## **REGULAR MEETING AGENDA**

**Tuesday, February 25, 2025  
6:30 P.M.**

## **Preliminary Site Plan and Special Use Review For Ypsilanti Township, Michigan**

<b>Applicant:</b>	UPH Ypsilanti Property LLC (Represented by Charles Paisley)
<b>Project Name:</b>	Culver's Restaurant and Drive-Through
<b>Plan Date:</b>	July 18, 2024
<b>Latest Revision:</b>	December 20, 2024
<b>Location:</b>	1410 Huron St. (On west side of South Huron Street, just north of Aldi site at Brinker Way)
<b>Zoning:</b>	FB, Form Based District – Town Center
<b>Action Requested:</b>	Preliminary Site Plan and Special Use Approval

C-103

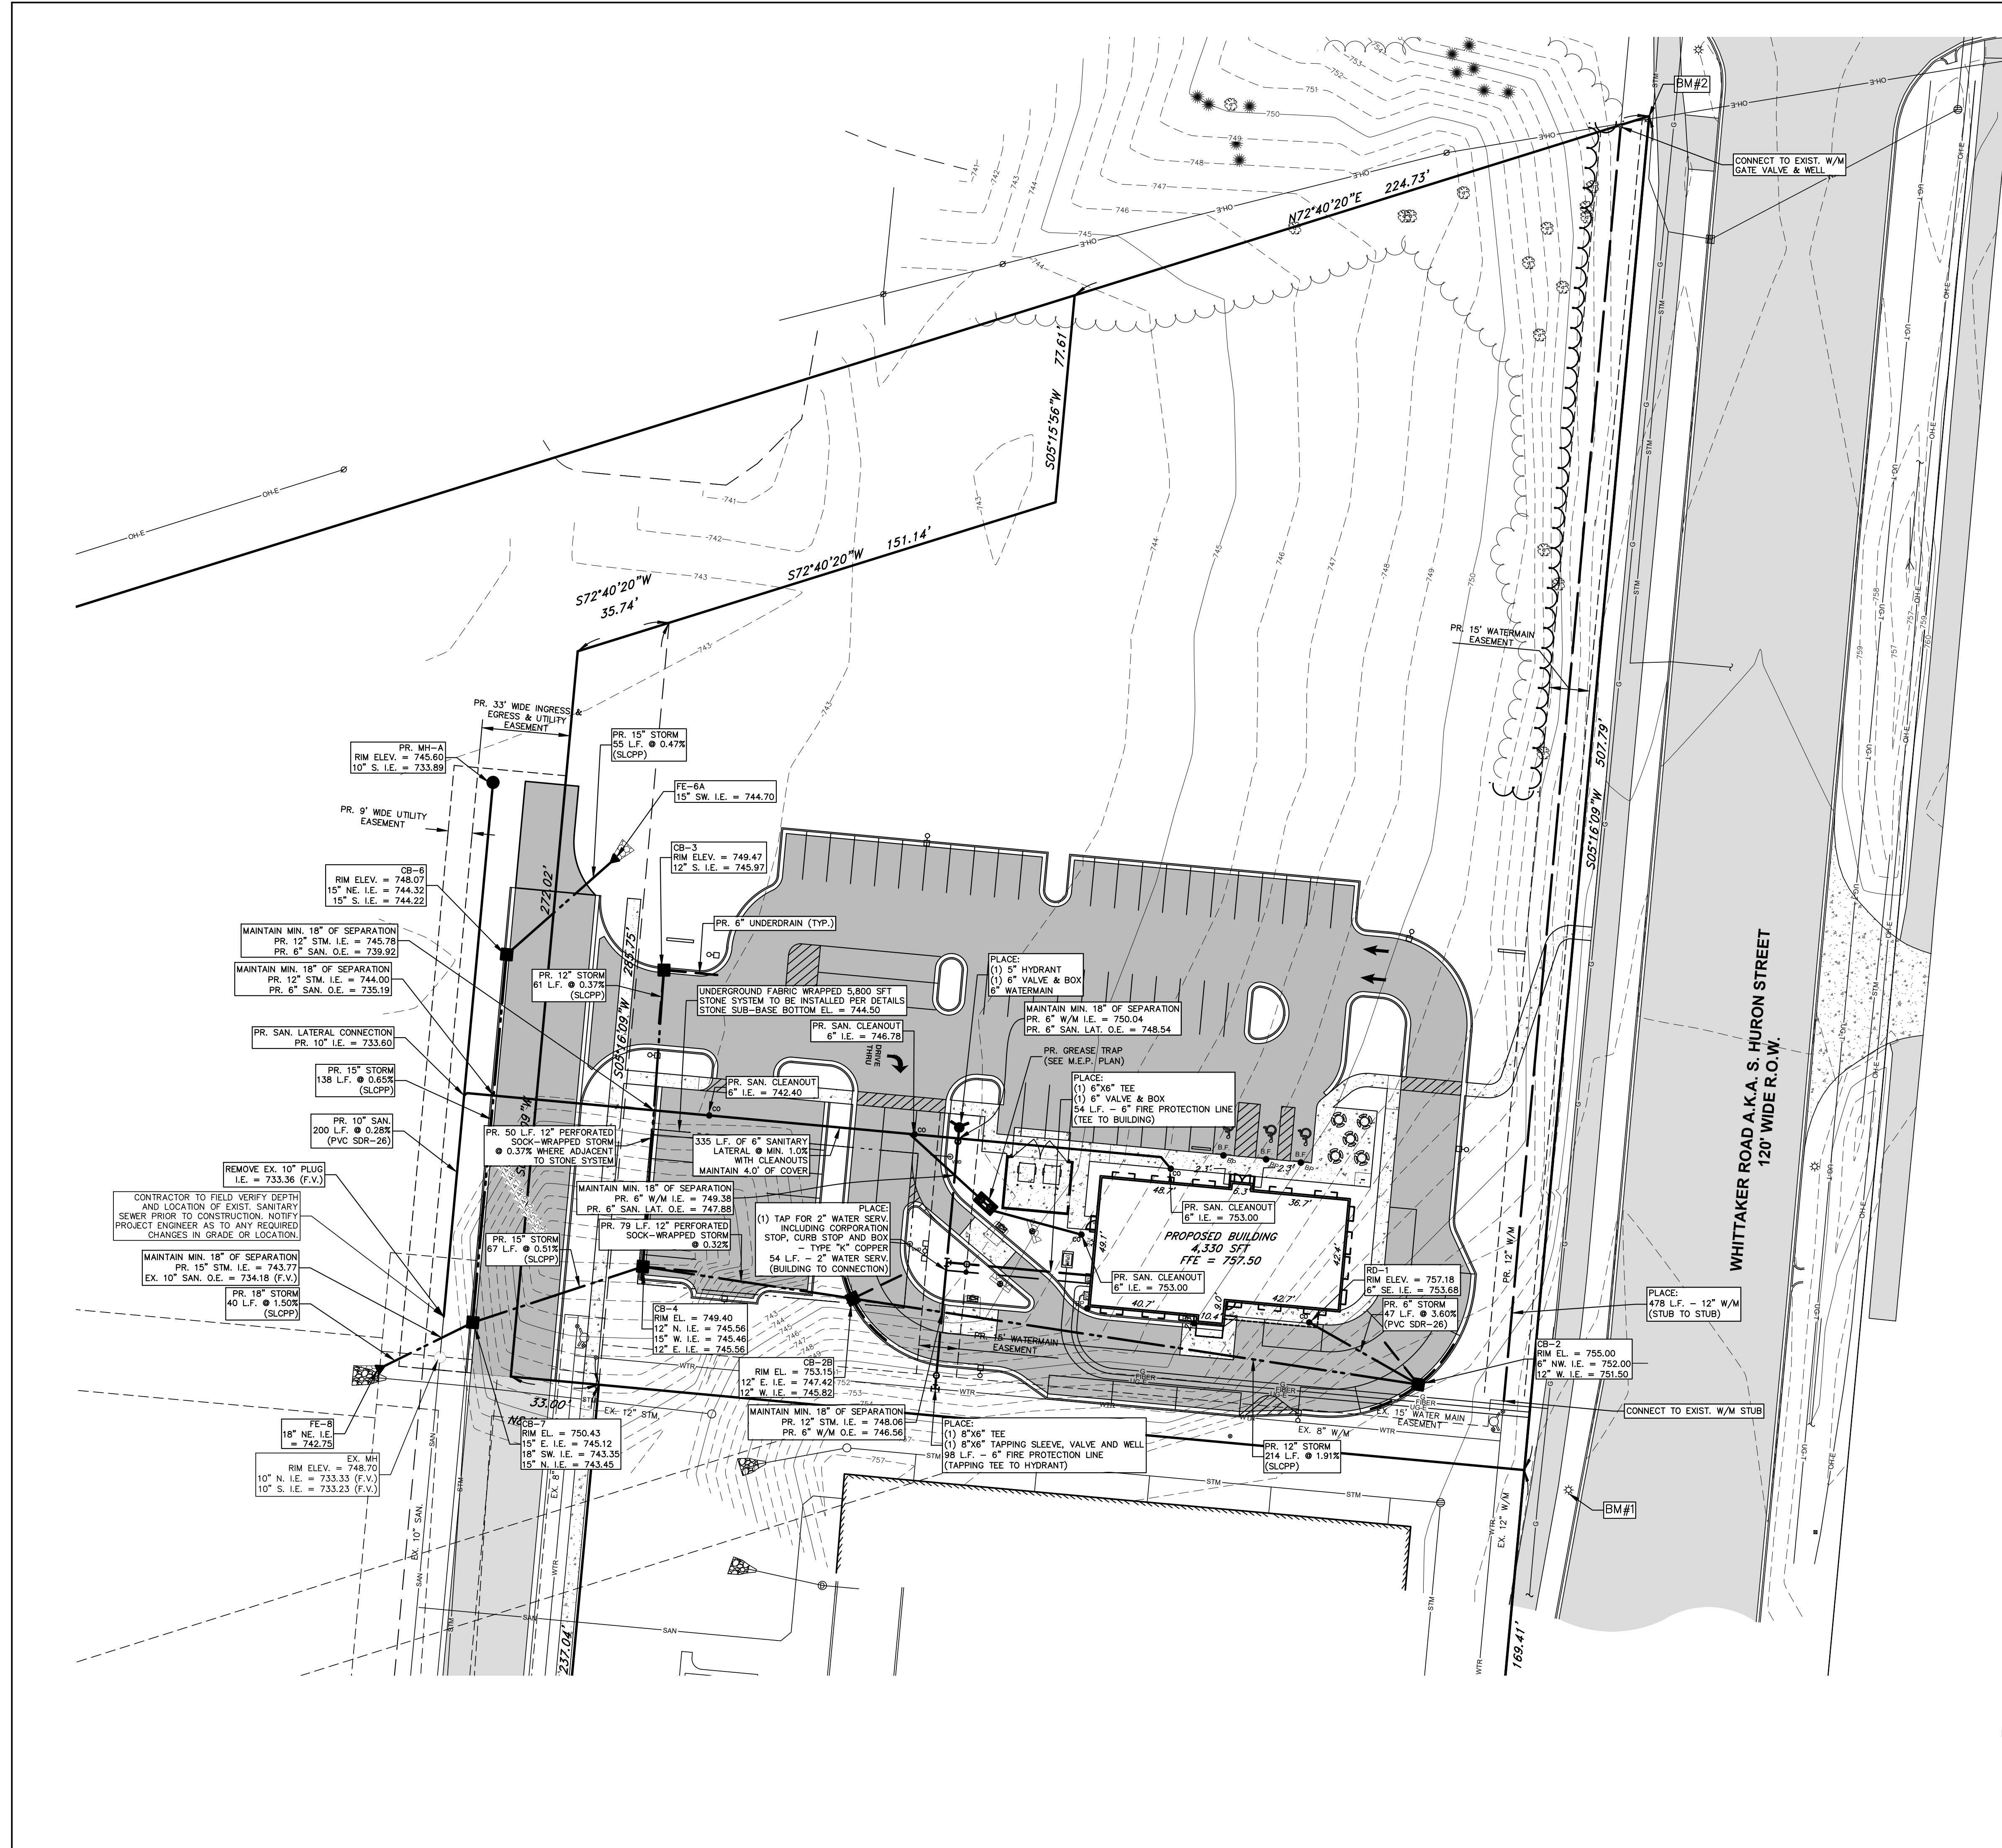
6. The applicant shall verify the invert elevations of CB-6 as there appears to be discrepancies between the plan view (Sheet C-103) and the profile view (Sheet C-203).

9. The applicant shall verify the rim/invert elevations and the name of the proposed sanitary sewer manhole on to the northwest as there appears to be discrepancies between the plan view (Sheet C-103) and the profile view (Sheet C-202).

SHEET NUMBER  
 L-1

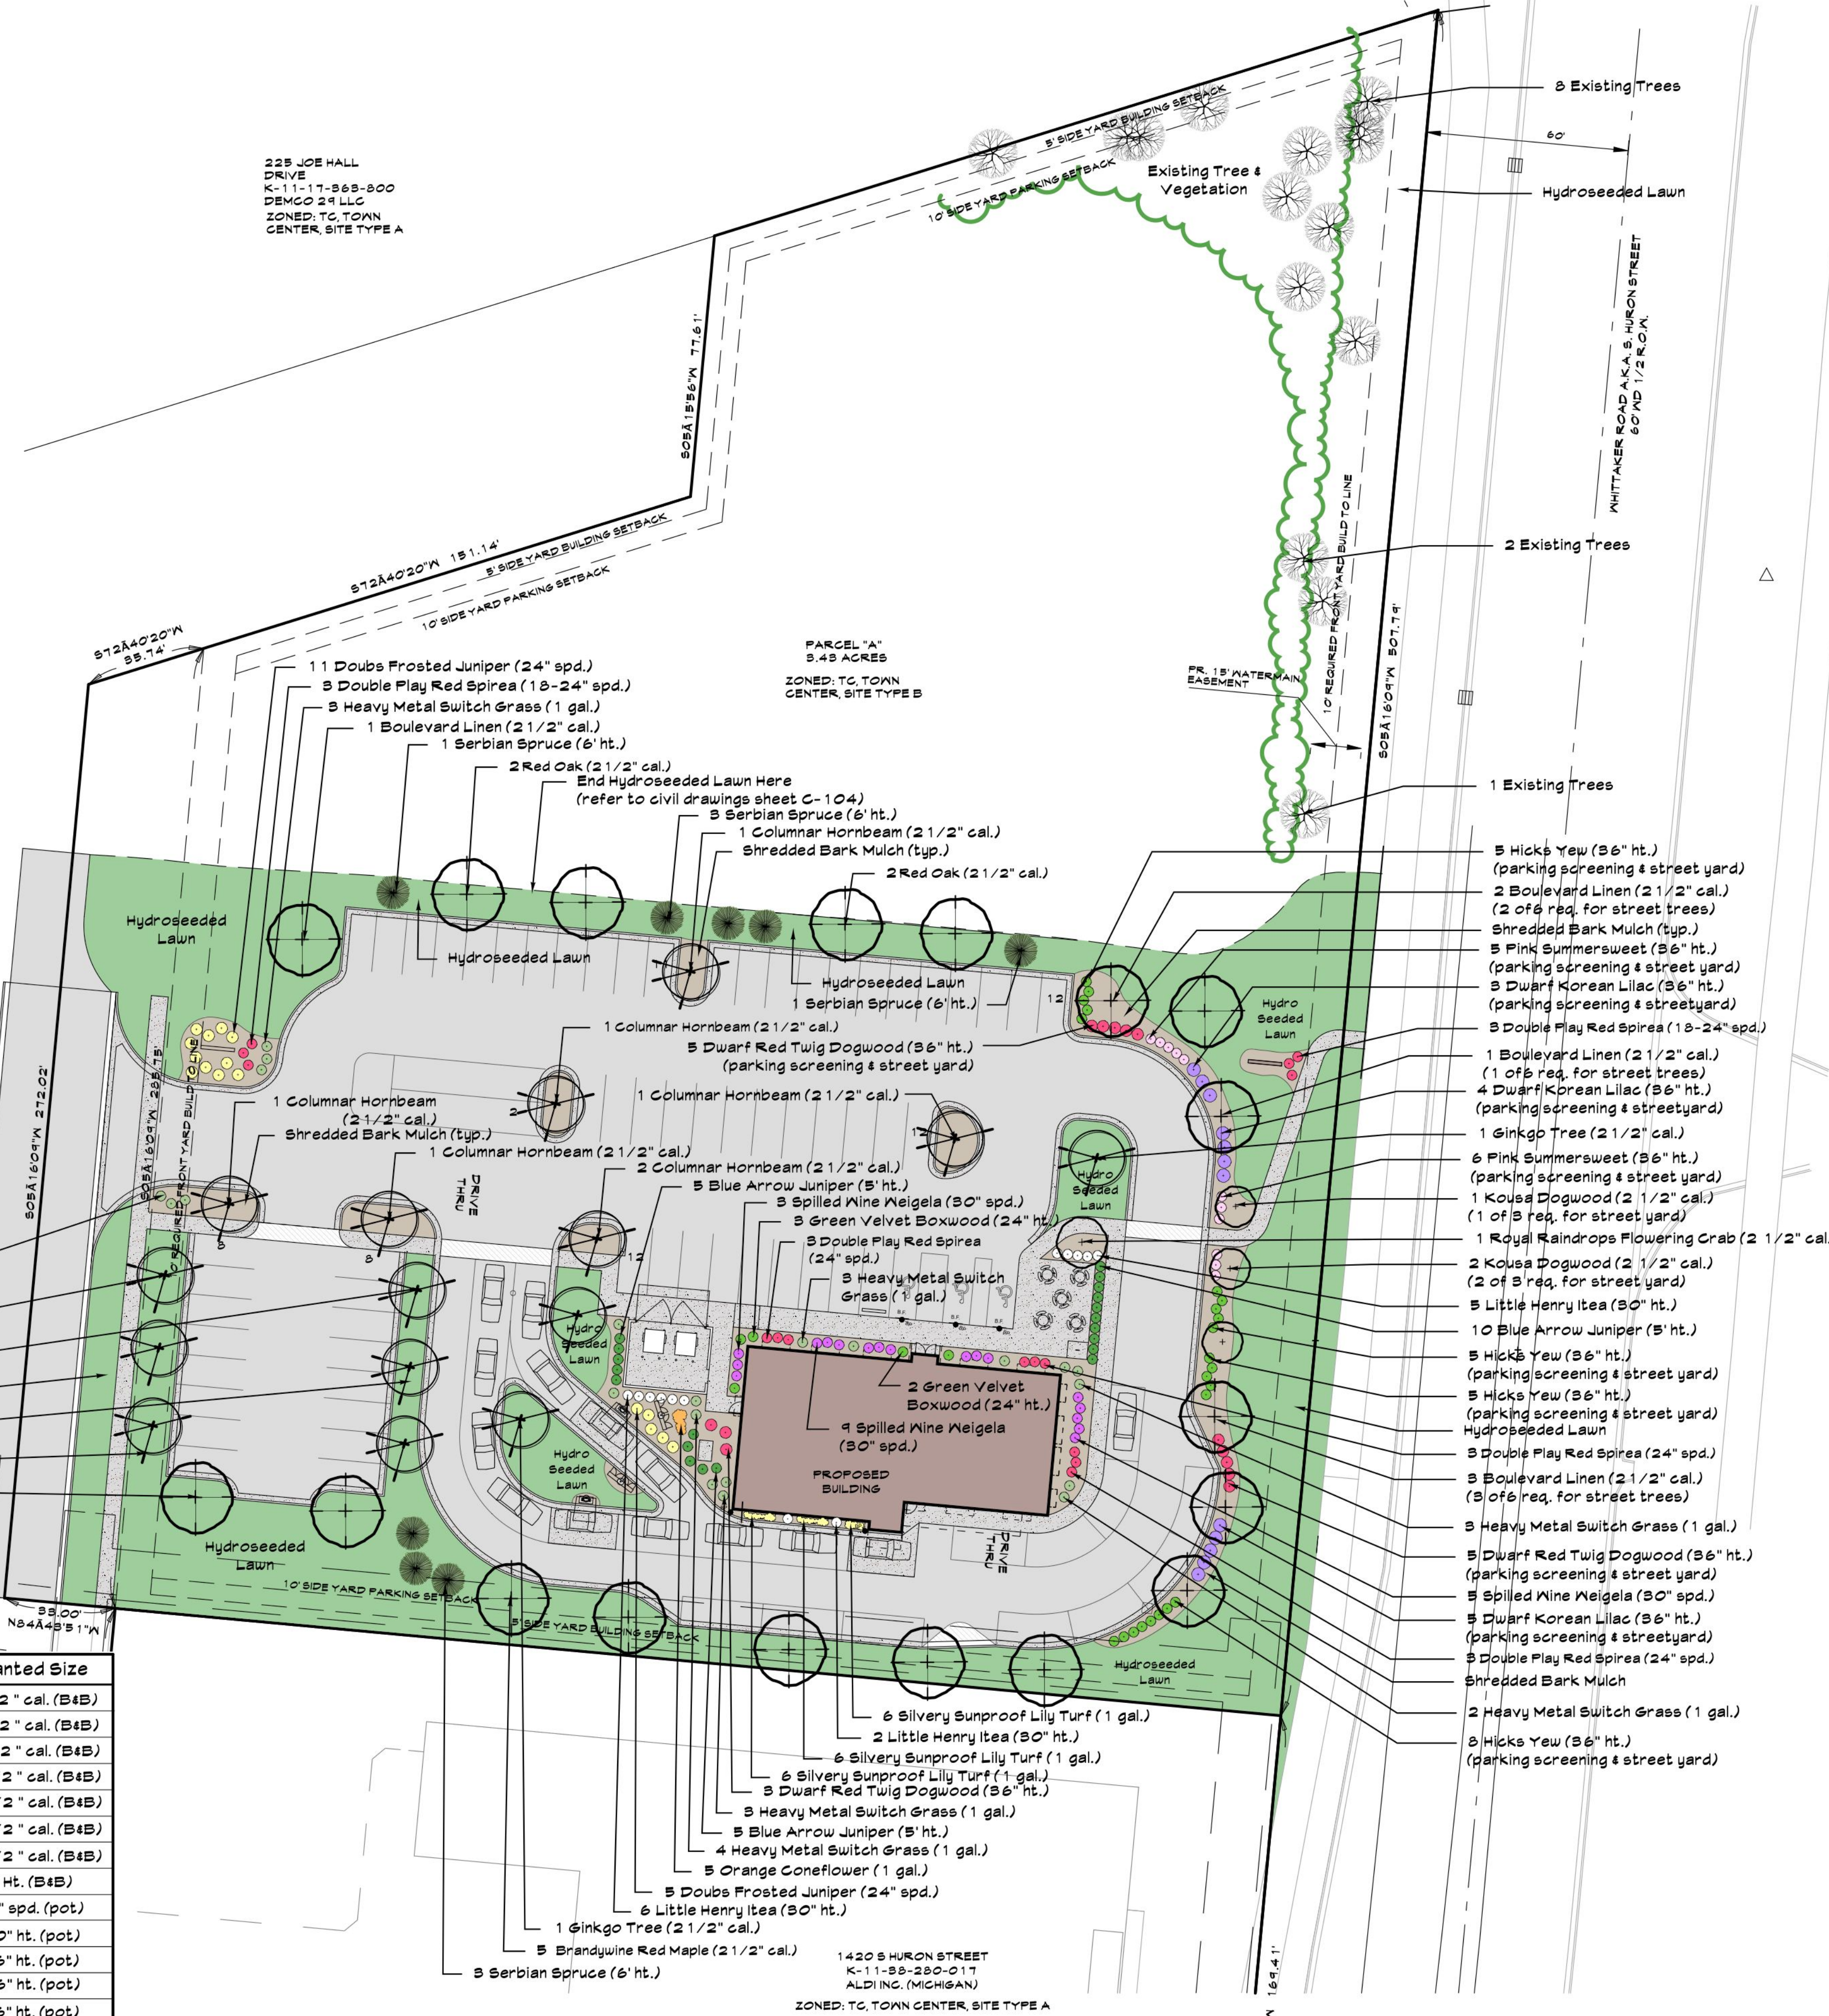
7. The applicant shall provide the hydraulic grade line on all storm sewer profiles.
8. The applicant shall overlay all existing and proposed utilities on the Landscape Plan (Sheet L-1) and note that trees shall not be placed directly above any utilities.

**D. Irrigation:** The ordinance requires that the Landscape Plan include a note stating that the site will have an underground irrigation system for all landscaped areas. This is provided in Note #8 on Sheet L-1.
